Access Compliance Report Public Rights-of-Way (Curb Ramps)

Main Street: SEA_GRAPE_RD	Cross Street: SNOW_BUSH_ST	Location: SE
---------------------------	----------------------------	--------------

ADA ID: RPRK211028135042	Ramp Type: Type 4 - Parallel	Initial Pass/Fail: Pass	Overall Compliance: No	Severity Score: 25
--------------------------	------------------------------	-------------------------	------------------------	--------------------

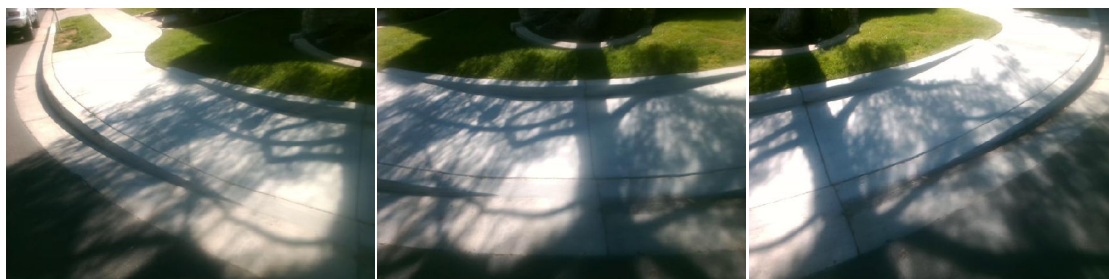
R204.3, R304.2.1, R304.2.2-Perp, R304.3.2-Para, R304.5.3, R305, R304.5.4, STD 1115

Compliance	Description	Data	Compliance	Description	Data
N/A	Ramp Length LT (in)	122	N/A	Ramp Length RT (in)	132
Yes	Ramp Width LT (in)	53	Yes	Ramp Width RT (in)	54
Yes	Ramp Run Slope LT (%)	5.3	Yes	Ramp Run Slope RT (%)	6.2
Yes	Ramp Cross Slope LT (%)	1.3	Yes	Ramp Cross Slope RT (%)	1.8
N/A	Landing Present	No	No	DWS Provided	No
N/A	Landing Length (in)	N/A	N/A	DWS Contrast	N/A
No	Landing Width (in)	N/A	N/A	DWS Length (in)	N/A
No	Landing Run Slope (%)	N/A	N/A	DWS Full Width	N/A
No	Landing Cross Slope (%)	N/A		DWS Offset Type	N/A
N/A	Landing Movement Obstructed?	No	N/A	DWS Offset Left (in)	N/A
	Landing Movement Type	Curb	N/A	DWS Offset Right (in)	N/A
N/A	Landing Shared	N/A			
N/A	Clear Space	Yes			
N/A	Clear Space To Crosswalk (in)	48			
N/A	Marked Crosswalk 1	No	N/A	Marked Crosswalk 2	No
	Crossing 1 Direction	N		Crossing 2 Direction	W
	Marked Crosswalk 1 Width (in)	N/A		Marked Crosswalk 2 Width (in)	N/A
N/A	Ramp Inside Crosswalk 1	N/A	N/A	Ramp Inside Crosswalk 2	N/A

Crossing 1 Slope (%)	2.9		Crossing 2 Slope (%)	2.8
	Crossing 1 Cross Slope (%)	2		Crossing 2 Cross Slope (%)	2.7
Yes	Gutter Ponding	No	Yes	Curb Slope	8.3
Yes	Gutter Lip Height (in)	0		Road Run Slope (%)	0.7
No	Gutter Run Slope (%)	8.8		Road Cross Slope (%)	3.9
Yes	Gutter Cross Slope (%)	0.9	No	Perpendicular Joint Present	No
Yes	Overall Surface Condition	Acceptable			
	Cross Gutter Present?	No		Spandrel Present?	No
	Replace Cross Gutter?	N/A		Replace Spandrel?	N/A

Remove & Replace Curb Ramp With Two New Directional Ramps or Equivalent. Remove & Replace Gutter.
